AT21CS01 Silicon Errata

The AT21CS01 devices that you have received conform functionally to the current Device Data Sheet (DS20005857B), except for the anomalies described in this document.

FIGURE 1: EXAMPLE SCHEMATIC

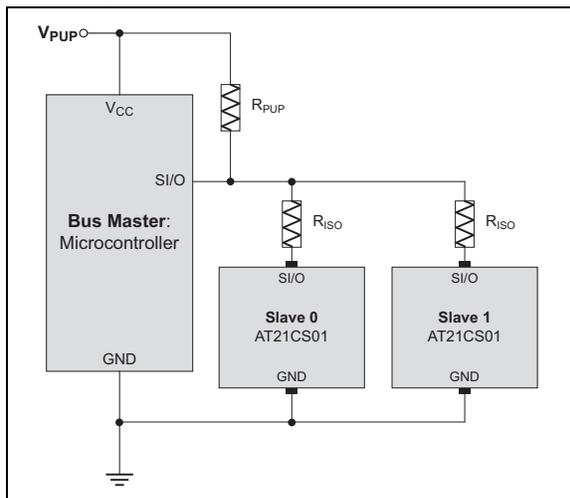
1. Issue: Reset and Discovery Failure with Multiple Devices on Bus

When multiple AT21CS01 devices are present on the single-wire bus, one or more devices may not reset properly after a device Reset or power-up event.

The device(s) that are not reset properly may remain active (driving S/I/O low) following the device Reset or power-up event, resulting in corrupted communication.

Modify the firmware to force S/I/O high during the entire t_{DACK} period following a device Reset or power-up event. Series resistors must be added to isolate the slave devices and reduce the output current. In addition, narrowing the Pull-Up Voltage V_{PUP} range may be necessary to meet timing and I/O level requirements during communication. [Figure 1](#) is an example Schematic with the isolation resistors R_{ISO} .
